## **RE: 780 Wallgrove Road, Horsley Park SSD-9601 Modification – Response to Submission - Transport Statement**

**TABLE 1: RESPONSE TO DPIE'S COMMENTS**

<b>DOCUMENT INFORMATION</b>	
SWEPT PATH ASSESSMENT	
PROPOSED HARDSTAND LOCATION	
FILE NAME AG0714-08-v1.dwg	SHEET AG01

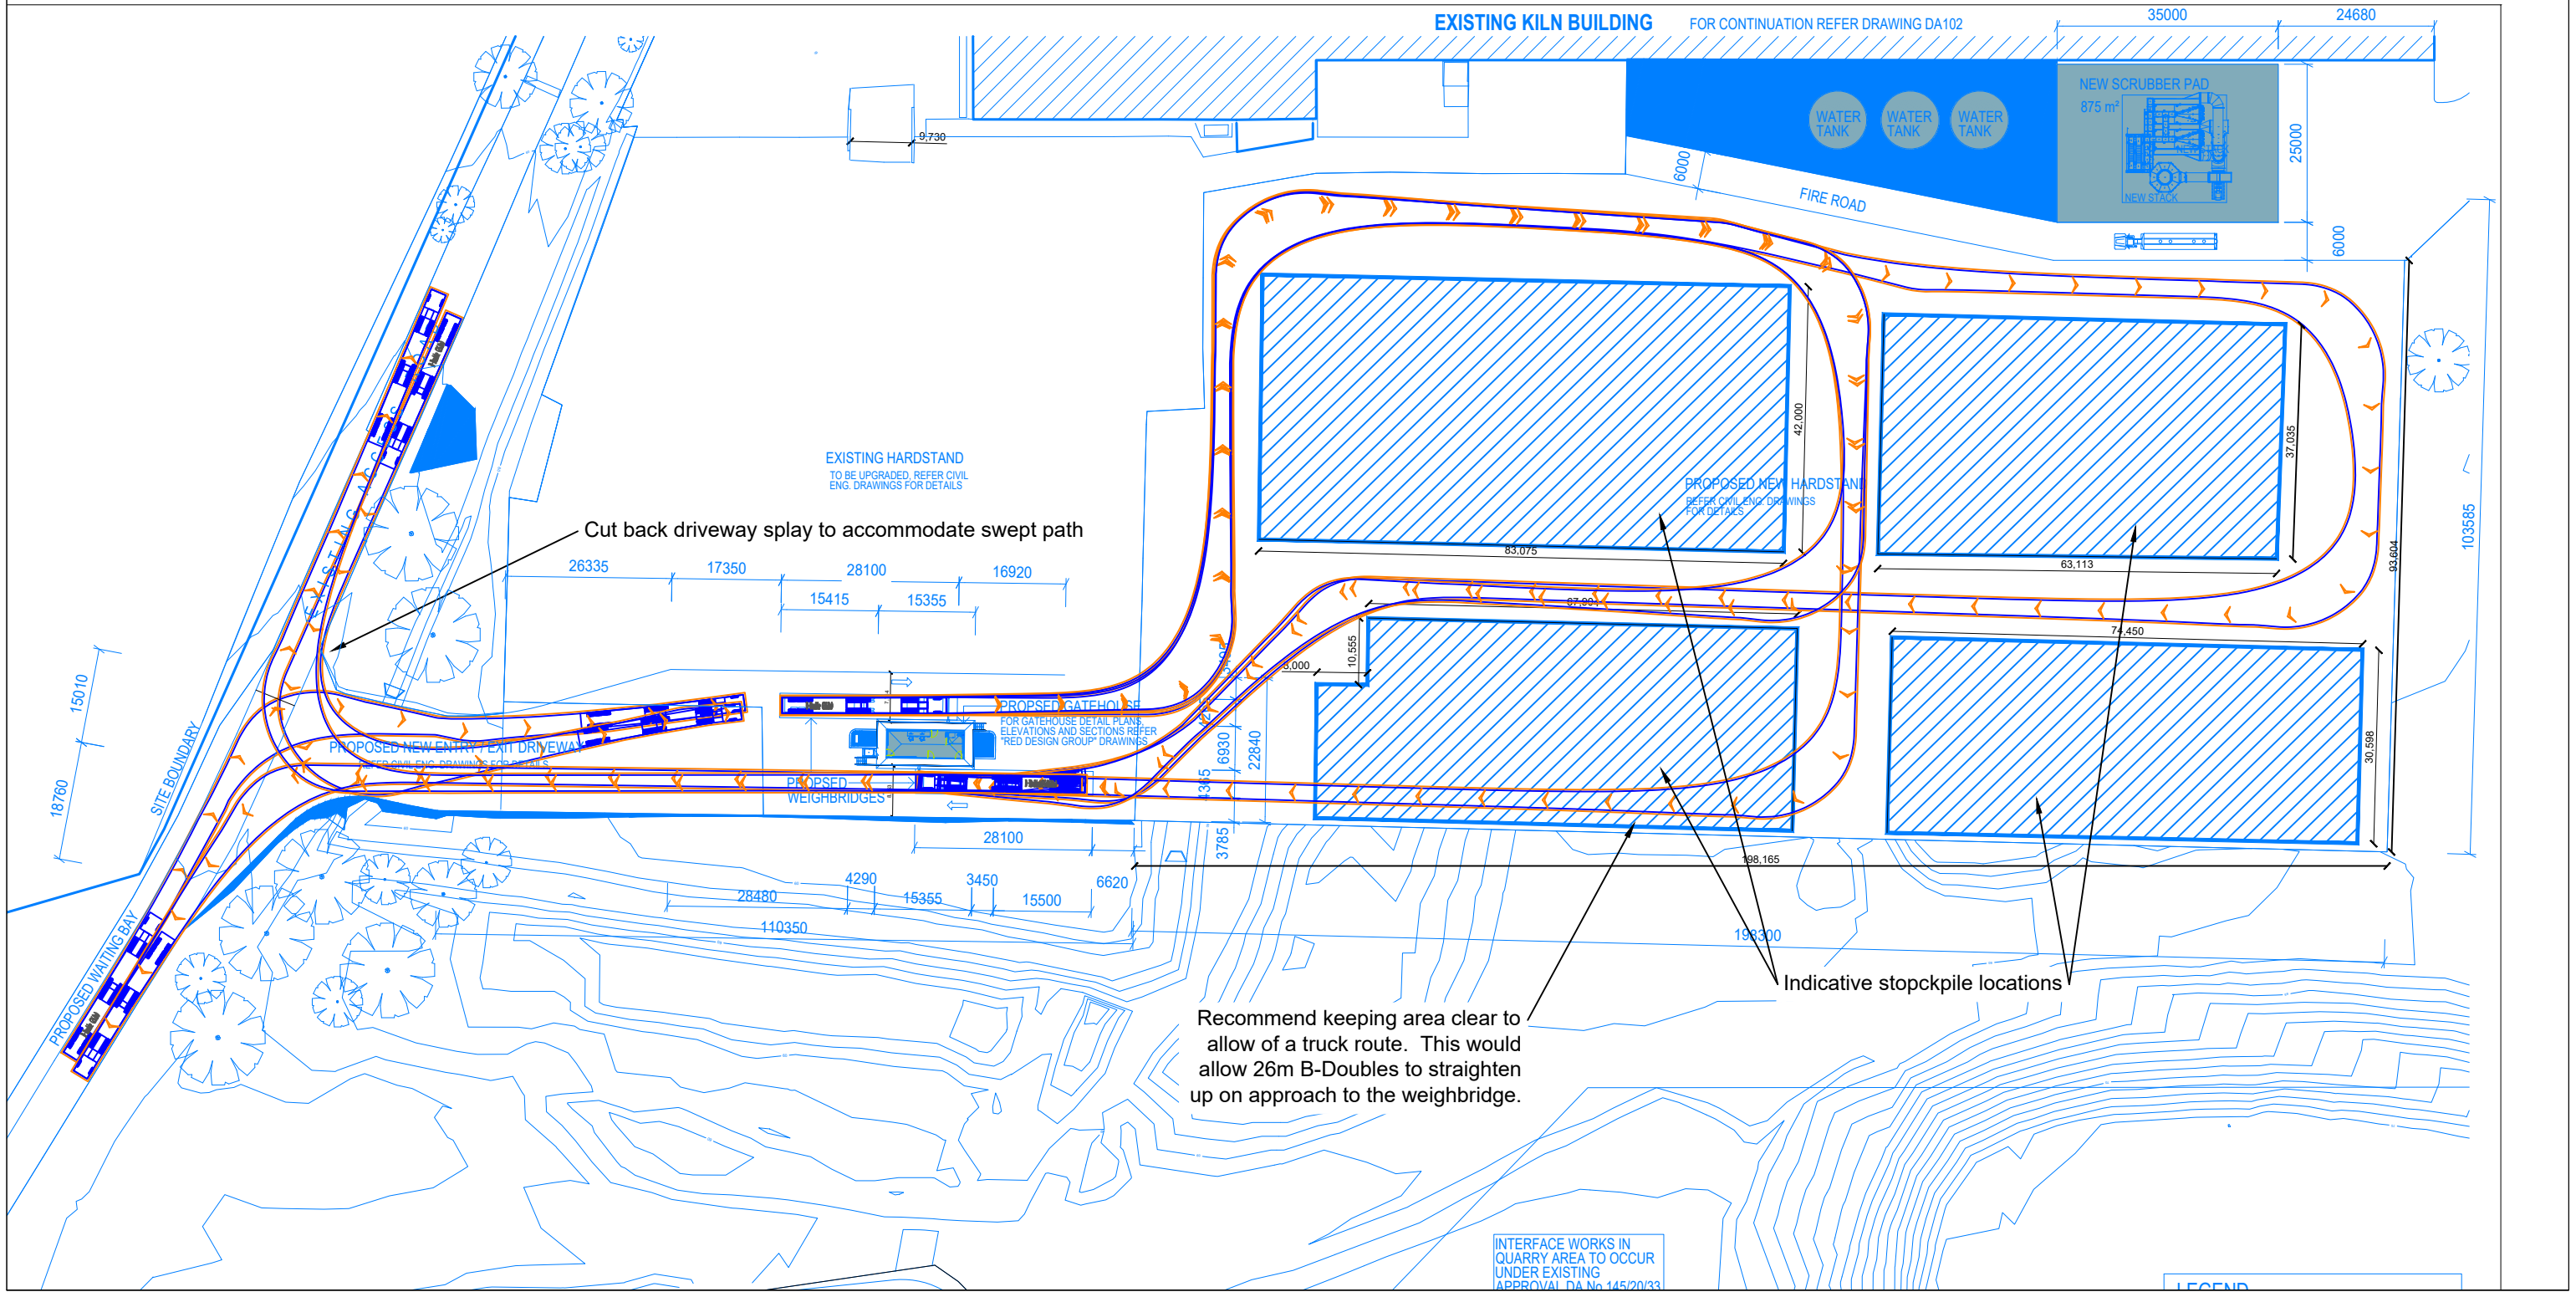
3	Swept path diagrams to demonstrate heavy vehicles travelling down the ramp can satisfactorily exit the site without conflicting with other users in the site	As discussed in Item 2, the HRVs represent fire trucks and are not expected to be on-site unless there is an emergency. As such, heavy vehicles will not conflict with other users within the Site during regular day to day operations.
4	Longitudinal section of the proposed entry driveway showing the grades and levels shall be submitted to Council for assessment	Please refer to the most recent plans for the proposed driveway longitudinal section provided by AT&L. The section has been designed to be in full compliance with the requirements stated in AS2890.2:2018 for 26.0m B-Doubles.
5	Swept path diagrams to demonstrate the intersection areas within the site have sufficient capacity to cater for two-way traffic movements;	<p>Ason Group prepared the Traffic Report for the SSD-9601 which stipulated a traffic generation of fewer than 10 vehicles per hour (vph) in the peak hours.</p> <p>The traffic generation of the MOD 1 SSDA would an additional 10 heavy vehicles throughout the day, resulting in approximately 2-3vph in the peak hour.</p> <p>The projected heavy vehicle traffic generation is sufficiently low such that conniptions two-way flow at the internal intersections is not warranted. The design generally provides for one-way circulation in accordance with best practise from a safety and efficiency standpoint.</p> <p>It would be expected that a Signage and Line Marking plan to be issued will provide the</p>
